# **Bus Priority Infrastructure Program On-time running improvements Hornsby to Blacktown corridor**

## **Submissions report**

**January 2018**

Prepared by NGH Environmental and Roads and Maritime Services

*Figure 1-3 Detail of proposed changes as presented in the REF which went on public display (Locations #11, #12, #20, #23 and #24)*

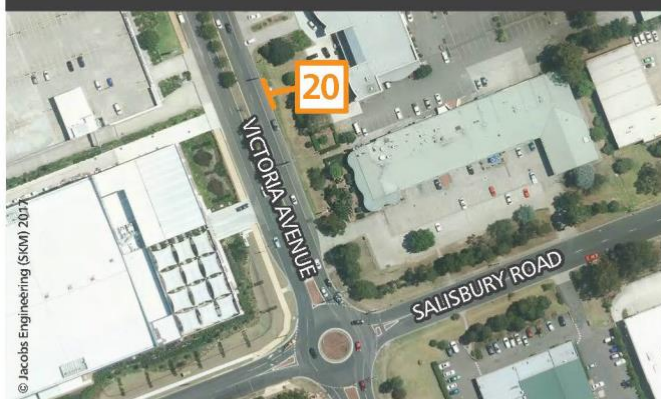
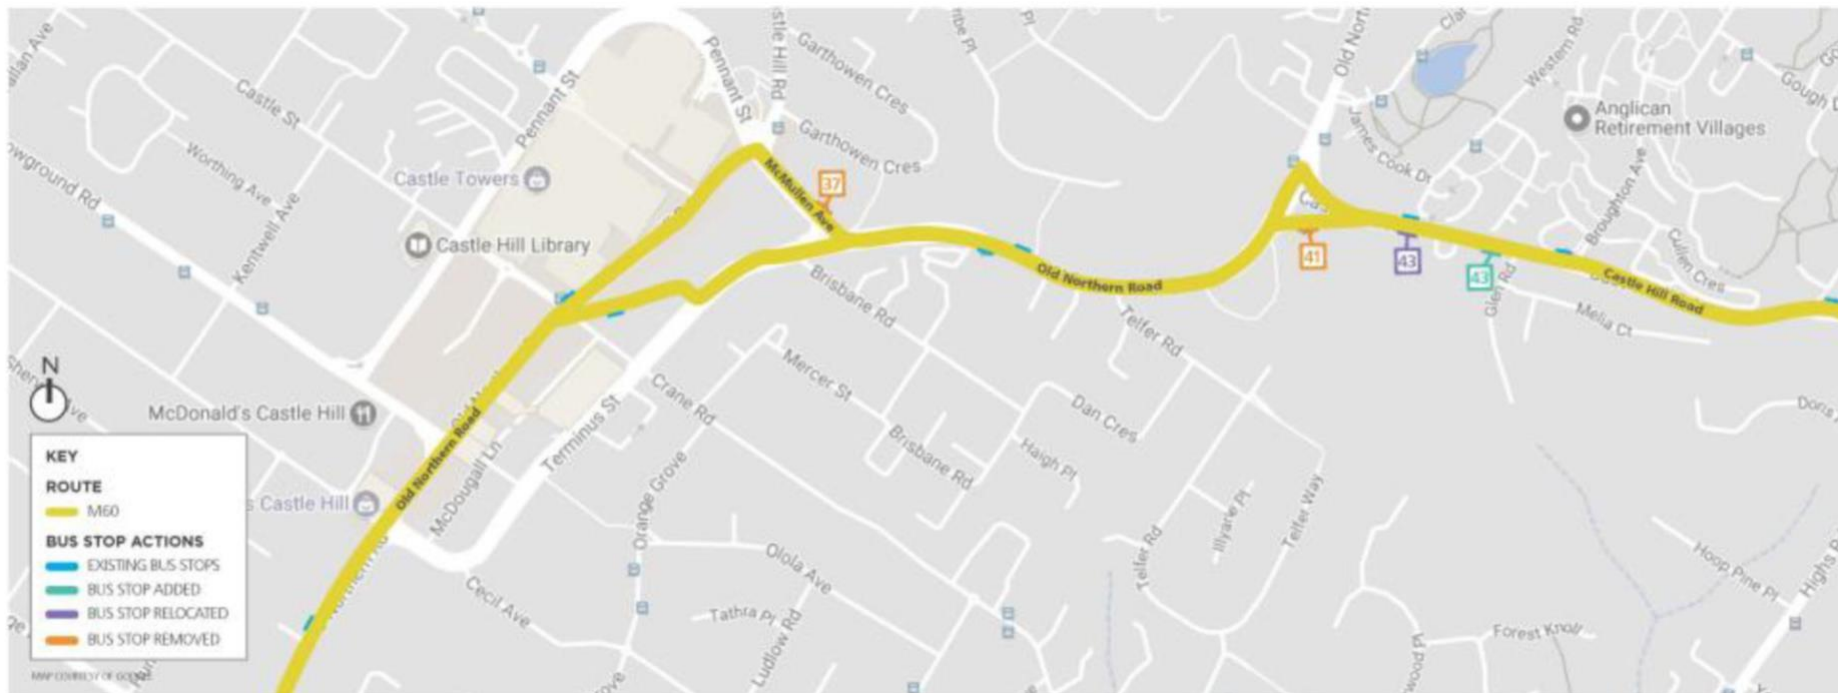
- Does not support removing T71 bus stop with shelter in Victoria Avenue (proposed action #20). It is quite well-placed, being outside Bunnings Warehouse and Service NSW. Suggests it would be better to add a corresponding bus stop on the opposite side of the road.

*Figure 1-5 Detail of proposed changes as presented in the REF which went on public display (Locations #37, #41 and #43)*

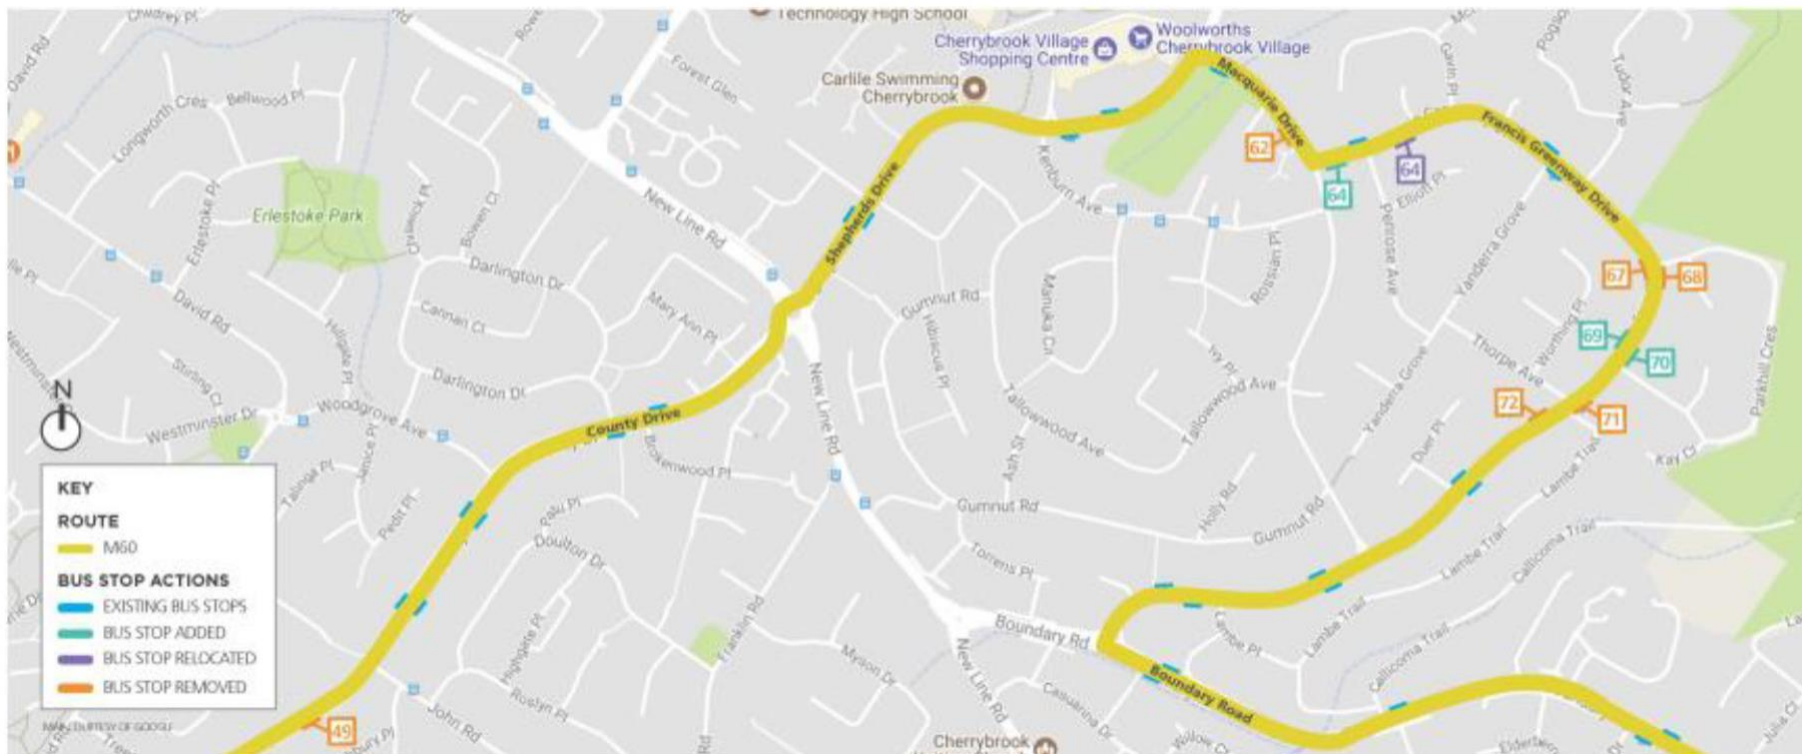
- Members of the Castle Hill Senior Citizens Club use bus stop #37 for collecting and dropping of customers for various organised trips. Removing bus stop #37 would inconvenience club members, including seniors, who use this bus stop.
- Action 37 is to remove bus stop #37 in McMullen Ave. We understand that M60 buses never stop here. The matter should be investigated in case some error would be compounded by removal of bus stop #37.

Bus stop #37 is likely to become redundant in the near future as new bus routes are planned around the completed Castle Hill Metro Station upgrades.

*Figure 1-9 Detail of proposed changes as presented in the REF which went on public display (Locations #99, #102, #108, #112, #122 and #123)*

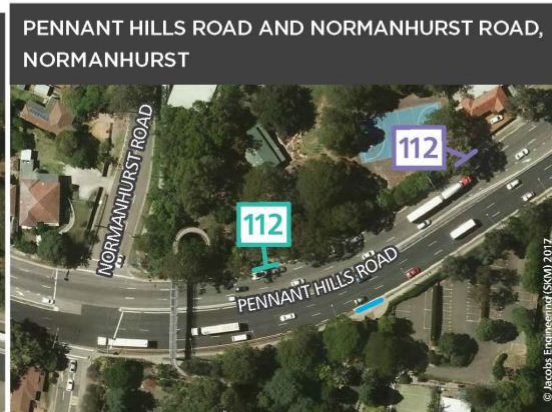
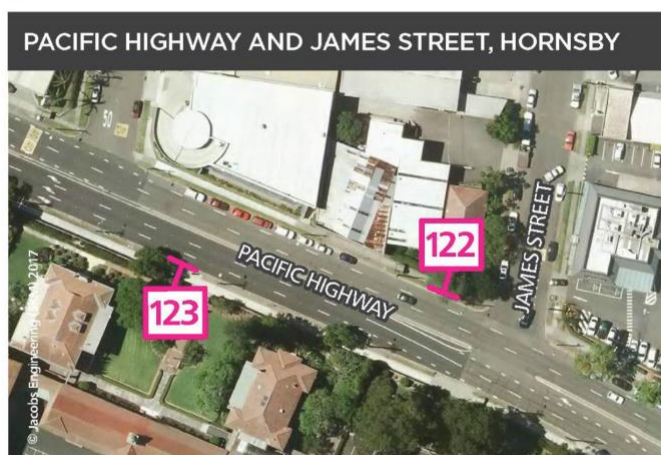
- The bus stops between Waitara and Hornsby (bus stops #120, #121, #122 and #123) are not placed near safe crossings. Two of them are outside and opposite the front gate of a school (Barker College) (bus stops #122 and #123) with no suitable means of crossing and should be moved to a safer location. The tidiest solution would probably be to have a pair of bus stops immediately west of the Unwin-Romsey junction and another pair at the College-Pretoria junction. The traffic signals should be adjusted to provide a safe right turn from the left-hand lane for Hornsby-bound buses at that point.

Opal data indicates that bus stop #108 is used by 26 customers compared to one customer at bus stop #110 (24 hour average weekday). However, bus stop #108 is more suitable to remove for the reasons described in section 3.19.1 of this report.

Figure 5-1 Proposed location of new bus stop #46 (source: Bitzios concept design)

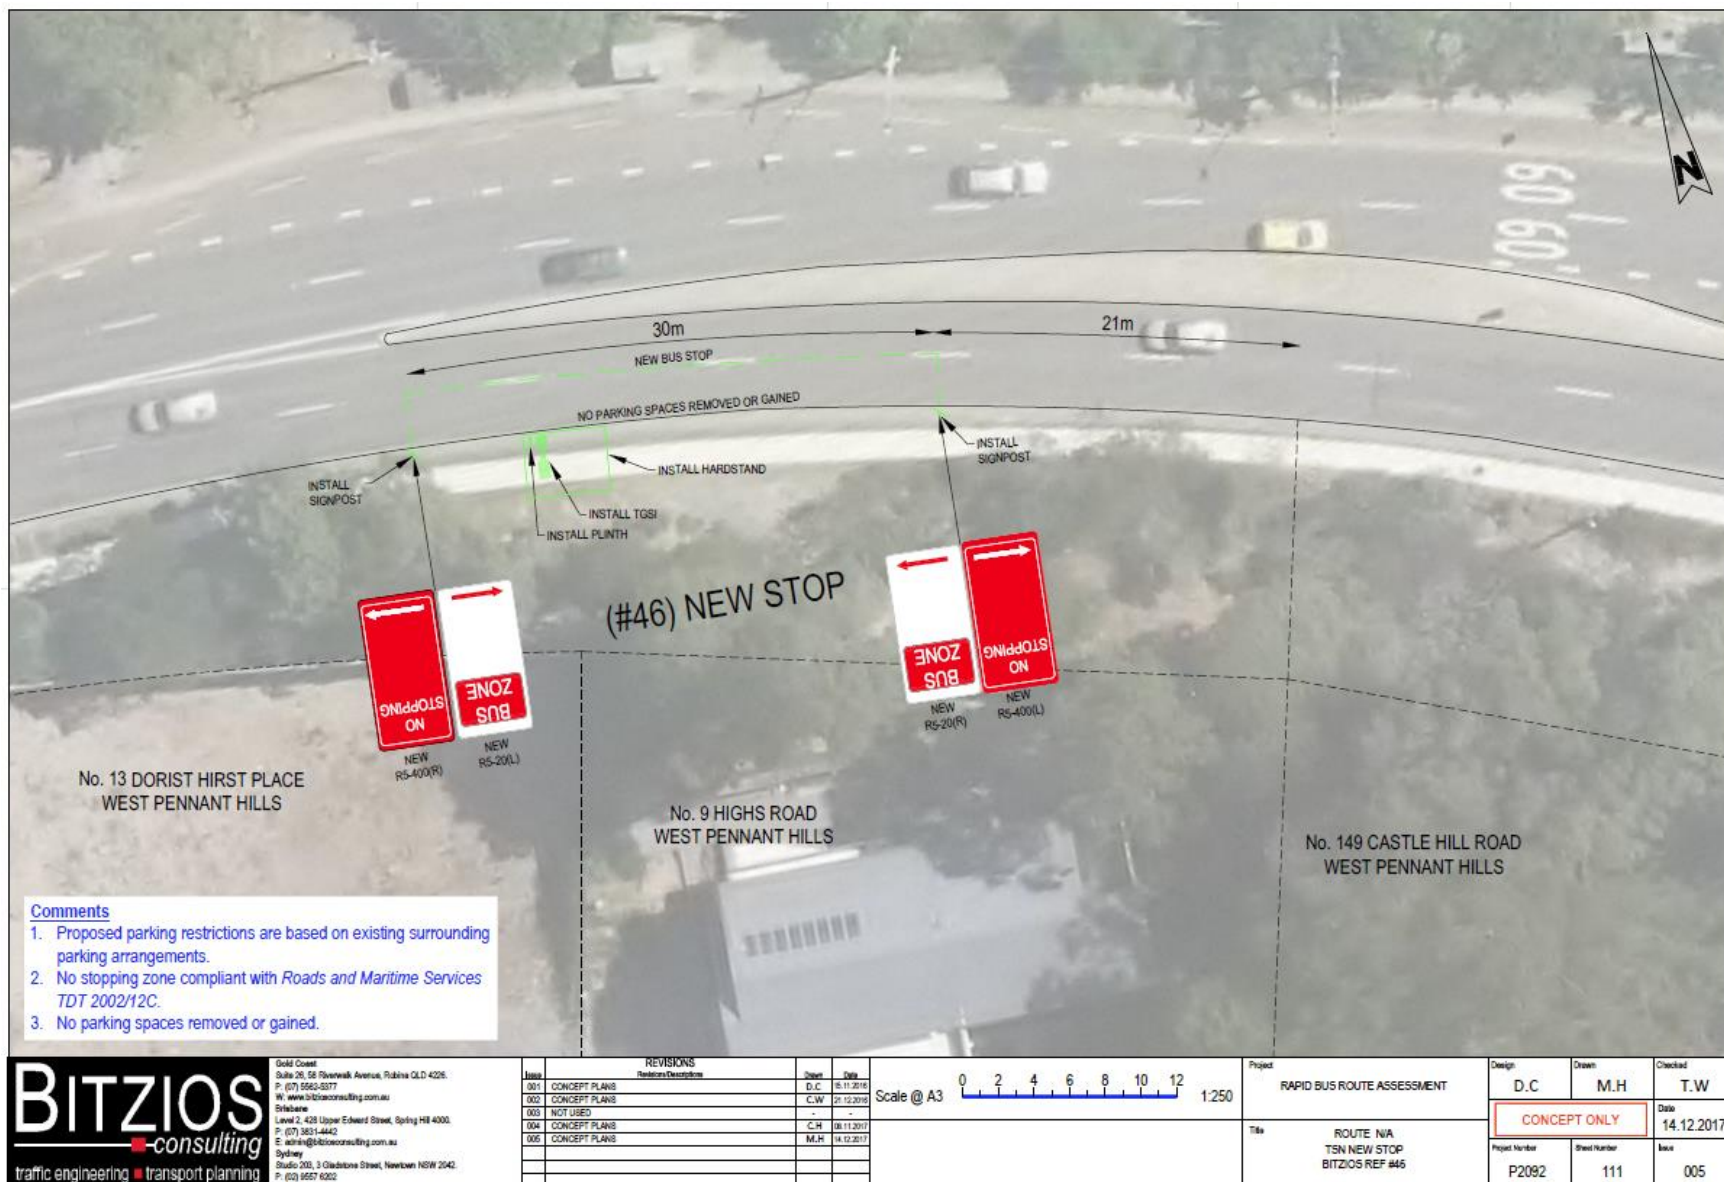
- Request to add or reinstate bus stops at:
  - Southern side of Castle Hill Road opposite (or nearby) the current northern side stop just before County Drive.

Roads and Maritime propose to construct a new westbound bus stop on Castle Hill Road about 70 metres west of Highs Road (referred to as 'bus stop #46' – TSN to be confirmed during implementation). Table 5-1 provides a summary of the justification for the new bus stop in this location. The proposed location and the resulting works required to establish this new bus stop is shown on Figure 5-1.
